car stereo Service Bulletin No.66

Model: XR-787R (CONNECTION WITH CDX-5)

Date: July 31, 1986

Subject: Instruction Manual Correction

4-SPEAKER CONNECTION—with a Sony compact disc player such as the CDX-5

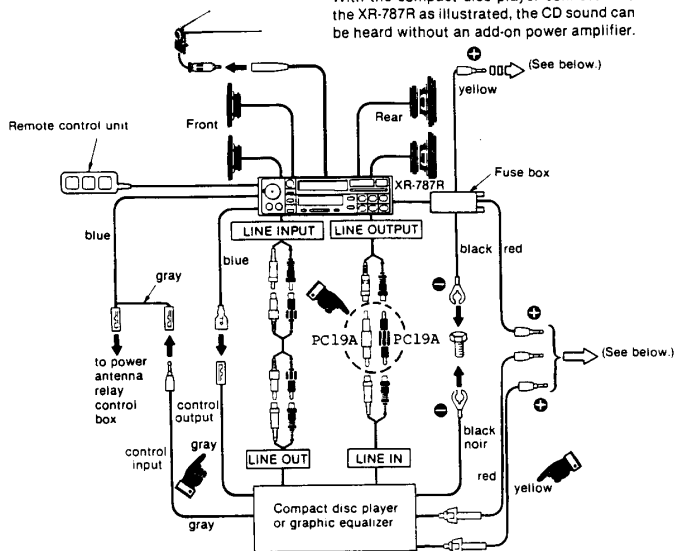
Note the connections in the hook-up diagram for the XR-787R and CDX-5.

With the compact disc player connected to the XR-787R as illustrated, the CD sound can be heard without an add-on power amplifier.

Also note when the XR-787R and CDX-5 are connected together. Radio ON/OFF switch on the XR-787R must be OFF in order to use the tape deck or the CDX-5.

If the radio is ON, the tape deck and the CDX-5 will not function.
